**ENVIRONMENTAL RESTORATION AND WASTE MANAGEMENT
DOCUMENT CHANGE NOTICE (DCN)**

DOCUMENT NUMBER 21100-WP-OU 02.1,RO

TITLE		DATE	DCN NUMBER
Phase II RFI/RI Work Plan (Alluvial)		November 22, 1991	OU2-91-2
EXPIRES: <u>February 25, 1991</u>			
LIMITATIONS: _____			
Item Number	Page	Step or Paragraph	Changes (Use DCN CONTINUATION SHEET for additional space)

Subcropping Sandstones Cases

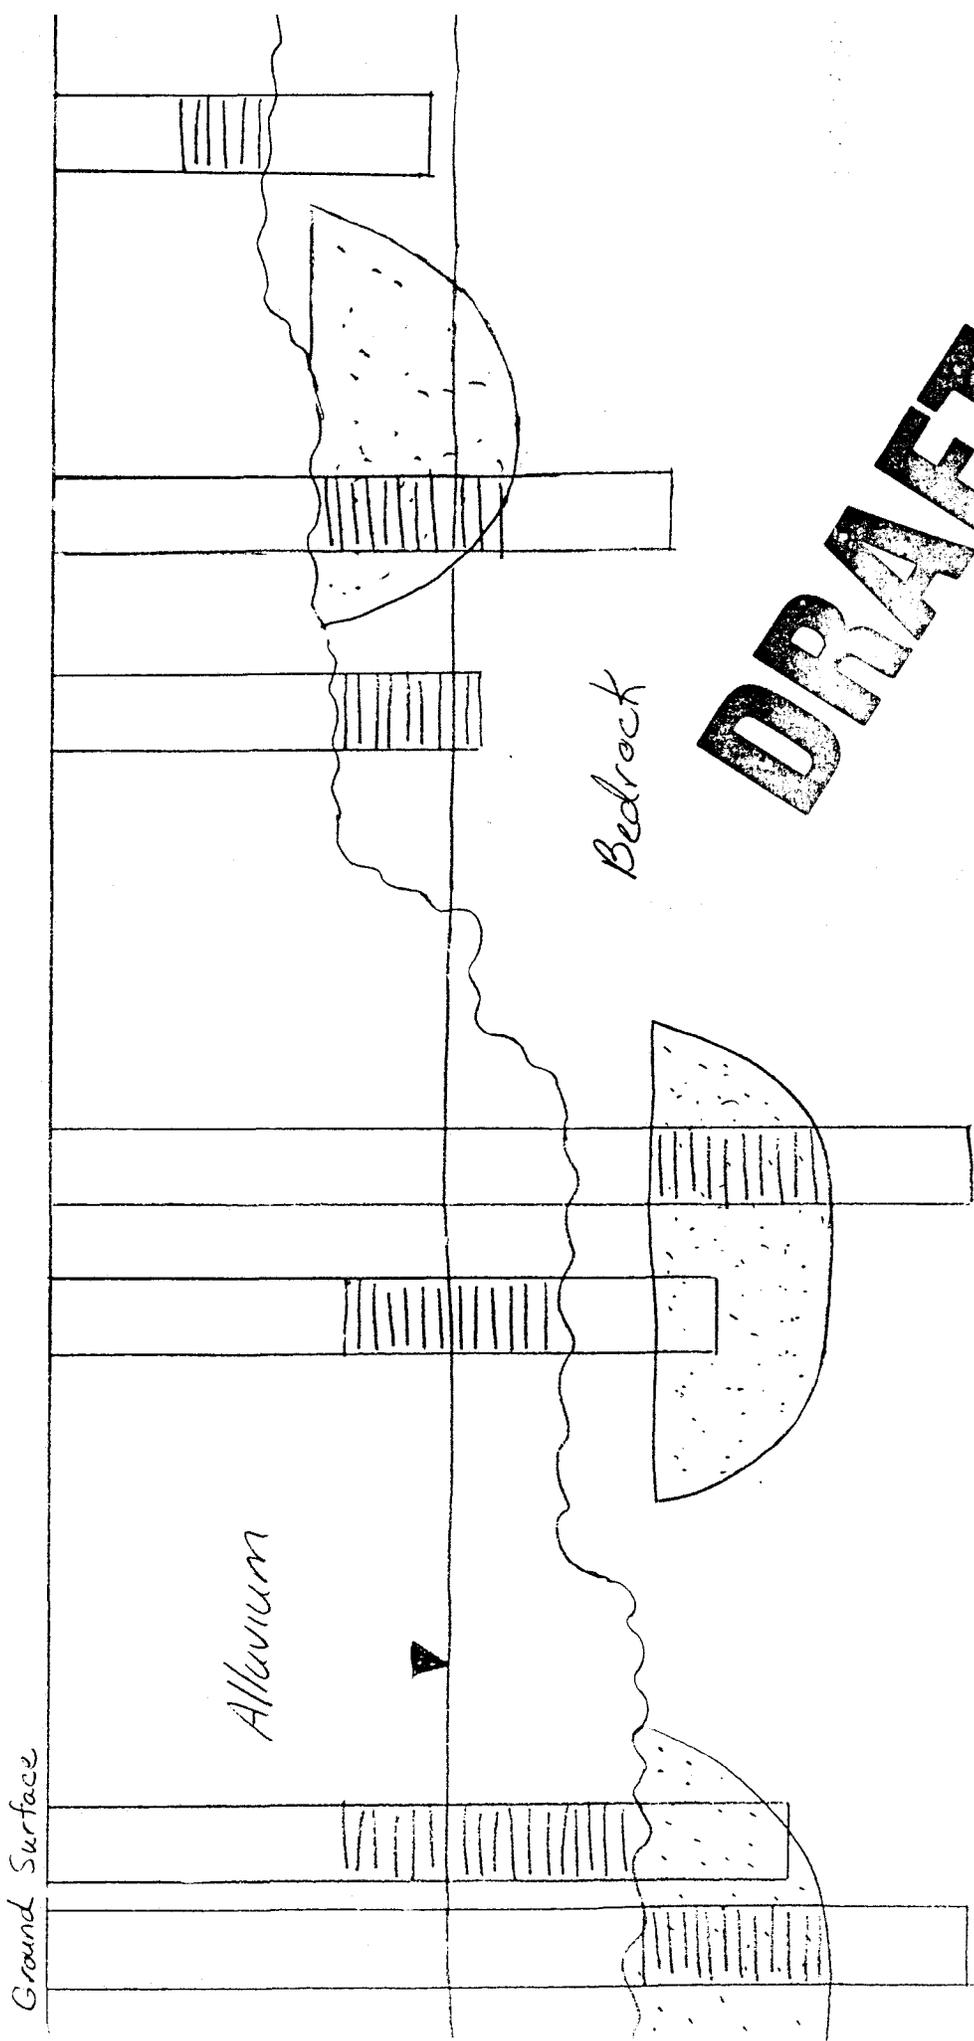
(2)	5-17	Section 5.2.2 Paragraph 2	<p>The requirement to set surface casing and complete the borehole as a bedrock well if a 3-foot thick fluvial sandstone sequence is encountered will be changed. If a fluvial sandstone sequence having a minimum thickness of 3 feet is encountered while drilling the required six feet into bedrock, the field geologist may decide to backfill the hole and complete the well as an alluvial monitoring well. The completion requirements are dependent on the stratigraphy of the overlying material and the depth to the top of the water table.</p> <p>Cases A through D in the attached diagram illustrate the anticipated subcropping conditions.</p> <p>Case A: A subcropping fluvial sandstone sequence is in contact with the overlying alluvium. Under this condition, the field geologist may continue drilling through the sandstone sequence until approximately 6 feet of claystone is encountered. The hole will then be backfilled and a bedrock monitoring well installed without setting surface casing. If the subcropping sandstone sequence has a saturated thickness greater than 10 feet, two bedrock monitoring wells will be installed. Screens will be set such that the upper and lower portions of the sand sequence is monitored. If the overlying alluvium is saturated, the bedrock monitoring well(s) will be offset with an alluvial monitoring well.</p> <p>If the field geologist decides to complete the first hole as an alluvial monitoring well, the bedrock should not be penetrated beyond six feet. The alluvial monitoring well will be offset with a bedrock monitoring well(s) as described above.</p> <p>Case B: Approximately three to five feet of claystone separate the alluvium from the fluvial sandstone sequence. Under this condition, drilling should stop at six feet into bedrock, the hole should be backfilled and completed as an alluvial monitoring well. If the sandstone is saturated, the alluvial well will be offset with a bedrock monitoring well(s). If the sandstone is not saturated, only the alluvial well will be installed. If the claystone separating the alluvium from the saturated bedrock sandstone is less than 3 feet thick, complete the sandstone monitoring well as if the sandstone was in contact with the alluvium (Case A).</p> <p>Case C: The top of the water table is within the upper 6 feet of the bedrock. Regardless of the stratigraphy, if the top of the water table is within the upper 6 feet of the bedrock, a bedrock monitoring well will be installed.</p> <p>Case D: No water in the hole. If no water is encountered within the hole after six feet of the bedrock has been penetrated and no subcropping sandstone sequence has been encountered, only an alluvial monitoring well will be installed. If the alluvium is too thin to allow the installation of an alluvial monitoring well, the hole may be abandoned and an alluvial monitoring well installed approximately 15 feet from the original location, or an upper bedrock well may be installed. If a subcropping sandstone sequence is present, continue drilling through the sandstone as described in Case A.</p> <p>The placement of offset wells will be determined by the EG&G hydrogeologist and confirmed by the EG&G project manager.</p>

Item Number	Page	Step or Paragraph	Changes (Use DCN CONTINUATION SHEET for additional space)					
<p>Justification (Reason for change - Provide numbers to reference corresponding items above.)</p> <p>(1) The anticipated subcropping bedrock "sandstones" is a fluvial sequence composed of predominantly fine-grained sands, silts, and overbank clays. Several channel sequences may be stacked together in a zone rather than a single channel (see Phase II RFI/RI Work Plan [Bedrock] for a discussion of the Arapahoe Formation depositional model). As a result, not all of the rock within the bedrock sandstone channel sequences will classify as sand according to the Wentworth classification method.</p> <p>(2) The first hole drilled should not have to be completed as the bedrock monitoring well if the bedrock fluvial sandstone sequence is encountered. The decision to complete as an alluvial or bedrock well is dependent on the stratigraphy encountered and the depth to the top of water. In addition, it is not necessary to set surface casing when completing a bedrock well if the bedrock zone of interest is in communication with the overlying alluvium.</p>
